Access Compliance Report

Public Rights-of-Way

Intersection ID: 28656	Main Street: CAVETT_CT	Cross Street: HAMPTON_PLACE_DR	Location: SE
ADA ID: C1757EAE5DE0	Ramp Type: Perp	Initial Pass/Fail: Fail	Overall Compliance: No
Severity Score: 12.5			
Codes/Mitigation Info/Possible Solution		Field Measurements/Component Compliance

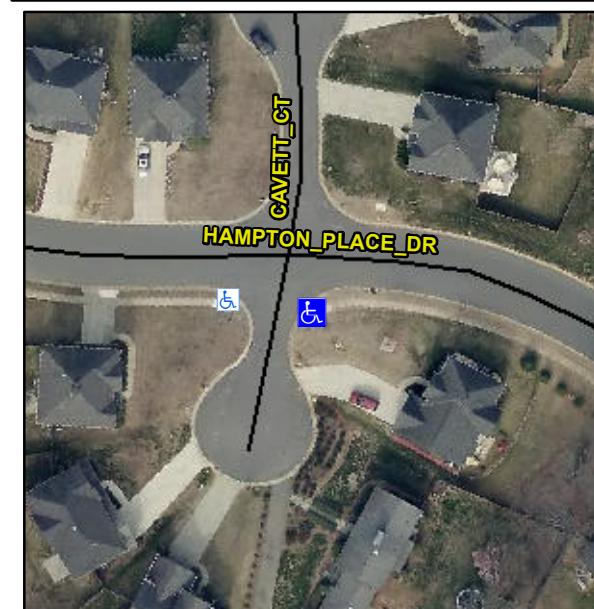
Not Found, R304.2.2

Compliance	Description	Data	Compliance	Description	Data
N/A	Ramp Length (in)	48.0	No	Ramp Slope (%)	8.5
Yes	Ramp Width (in)	48.0	Yes	Ramp XSlope (%)	0.3
N/A	Flare Type LT	N/A	N/A	Flare Type RT	N/A
N/A	Flare Slope LT (%)	N/A	N/A	Flare Slope RT (%)	N/A
N/A	Flare Traversable LT?	N/A	N/A	Flare Traversable RT?	N/A
N/A	Landing Length (in)	N/A	N/A	DWS Provided?	N/A
N/A	Landing Width (in)	N/A	N/A	DWS Contrast?	N/A
N/A	Landing Slope (%)	N/A	N/A	DWS Length (in)	N/A
N/A	Landing X Slope (%)	N/A	N/A	DWS Full Width?	N/A
N/A	Landing Curb? (Y/N)	N/A	N/A	DWS Offset (in)	N/A
N/A	Shared Landing?	N/A			
N/A	Gutter Ponding?	N/A	N/A	Gutter Slope (%)	N/A
N/A	Gutter Lip Ht (in)	N/A	N/A	Gutter X Slope (%)	N/A
N/A	Painted X Walk1?	No	N/A	Painted X Walk2?	N/A
	X Walk 1 Direction	To W		X Walk 2 Direction	N/A
N/A	X Walk 1 Width (in)	N/A	N/A	X Walk 2 Width (in)	N/A
	X Walk 1 Slope (%)	3.1		X Walk 2 Slope (%)	N/A
	X Walk 1 X Slope (%)	2.1		X Walk 2 X Slope (%)	N/A

Remove & Replace Entire Ramp.
